CONSTRUCTION SUMMARY

Red Oaks on Bayview - Trinimont Developments Inc.

LOT / PHASE	REG. PLAN#	HOUSE TYPE	
157 / 1	65M-4737	Evergreen Elev B

EVERGREEN ELEVATION B

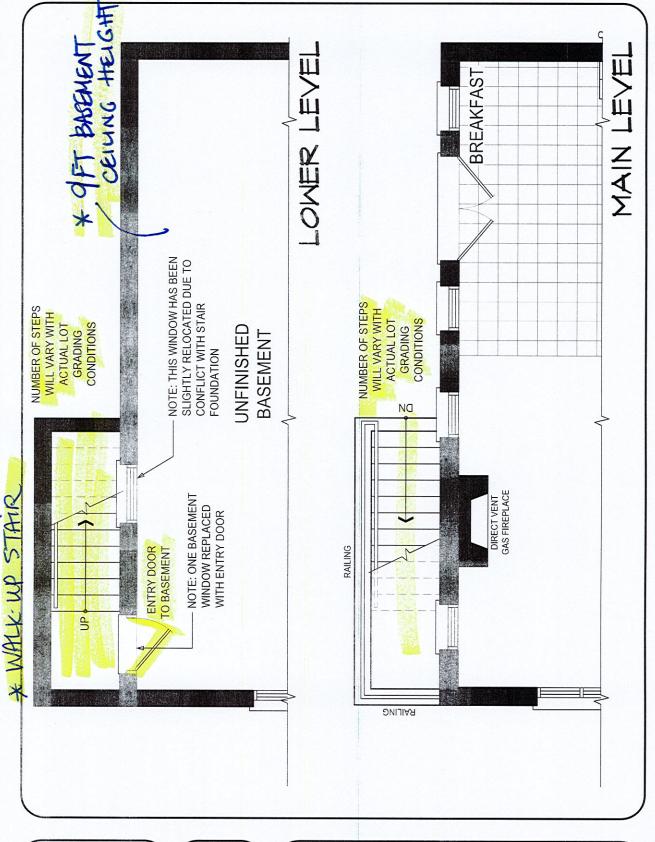
ADD EXTERIOR BASEMENT
MALK-UP STAIRS TO REAR
OF HOUSE.

2. 9FT BASEMENT CEILING HEIGHT.
